Title: **Stage 1 ROAD SAFETY AUDIT**
For;
Peter's Hill, Drogheda, Proposed Meeting Place.

Client: **Louth County Council**

Report reference: **1033R01**

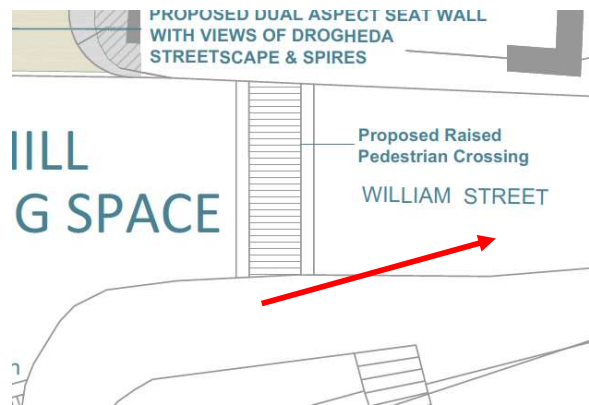
The proposed pedestrian crossing on William Street coincides with the end of the taxi rank. There is a risk that taxis may park at, or close to the crossing and thereby obscure the inter-visibility between drivers and crossing pedestrians.

It is recommended that the taxi rank is stopped short of the crossing. A solid build out may be required to prevent encroachment by taxis.

3.1	Yes	Yes (Partially)	The taxi rank will be terminated in advance of the crossing and a yellow box will be provided between the end of the rank and the crossing to achieve inter-visibility. The drawings have been amended to show this.	Yes

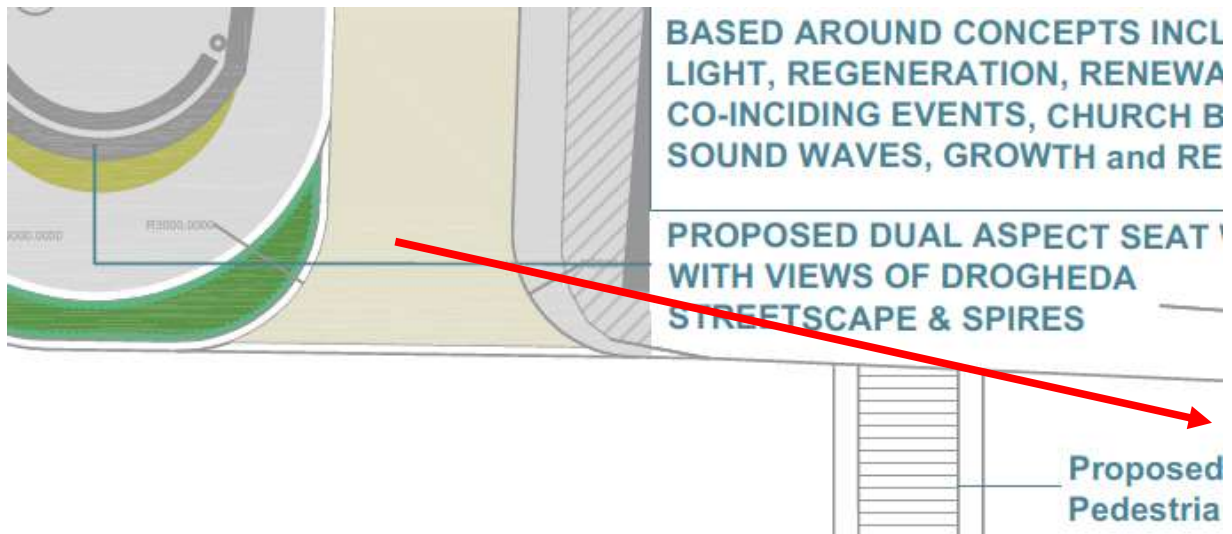
The existing footpath width is narrow on the northern side of William Street. This may not be wide enough to cater for the increased volumes of pedestrians using the crossing to get to/from the proposed meeting space. There is a risk that pedestrians will step onto the carriageway where they would be at risk of being struck by passing vehicles.

It is recommended that the footpath be widened between the meeting space and the crossing point and tapered back to the existing width further east, preferably after the pinch point. A wider footpath would also ensure a single lane of traffic on William Street at this location as currently the carriageway is between one and two lanes in width.

3.2	Yes	No	The widening of the footpath may lead to the creation of a pedestrian desire directly across to fair Street rather than using the proposed raised crossing on Magdalene Street. It is proposed to move the crossing closer to the Church access where the footpath is widest. This will provide greater space for pedestrians.	Yes

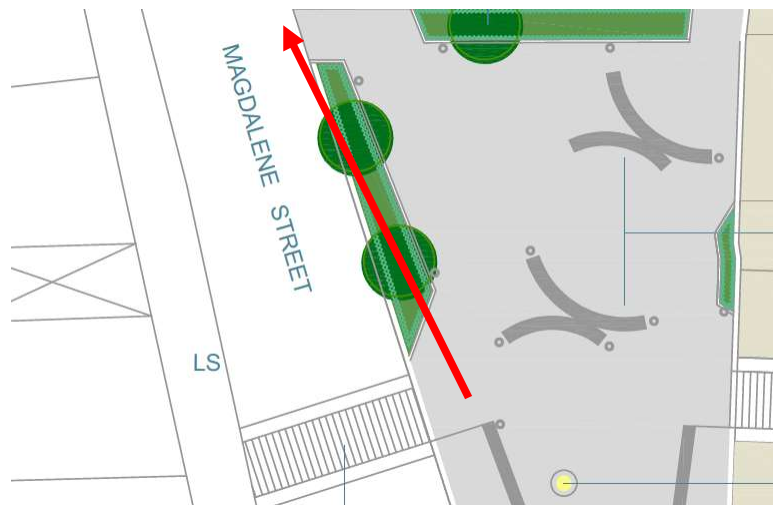
The visibility to the left for drivers exiting the Church grounds is limited although improved from the current layout due to the widened footpath and the presence of the proposed raised crossing.. There is a risk that a driver could enter William Street at an inappropriate time leading to a collision with through traffic.

It is recommended that, similar to Issue 3.2 above that the footpath between the Church access and the proposed raised crossing be widened.

3.3	Yes	Yes (Partially)	Visibility has been significantly improved , the footway is slightly widened but for reasons similar to 3.2 above a wider buildout may lead to an unintended desire line to Fair Street. The approach speeds will be very low due to the presence of the courtesy crossing.	Yes
